February 2019
FL799A
NHTSA #18V-742
Transport Canada #18-575
REVISED NOTICE

Subject: Honeywell Brake Light Pressure Switches

Models Affected: Specific Freightliner Cascadia vehicles manufactured March 8, 2016, through June 30, 2017.

Fig. 1, Brake Light Pressure Switch

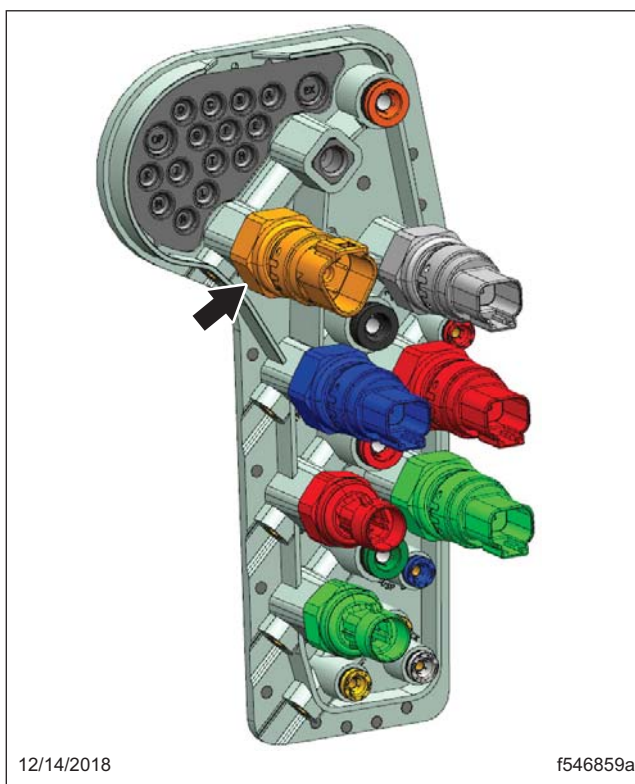
1. Check the base label (Form WAR259) for a completion sticker for FL799 (Form WAR260) indicating this work has been done. The base label is usually located on the front wall under the dash. If a sticker is present, no work is needed. If there is no sticker, proceed with the next step.
2. Park the vehicle, apply the parking brakes, and shut down the engine. Chock the tires.
3. Remove the lower steering column and throttle cover dash panels.
4. Disconnect and remove the brake light pressure switch. See [Fig. 1](#). Tag the switch for return per the Warranty Failed Parts Tracking shipping instructions.
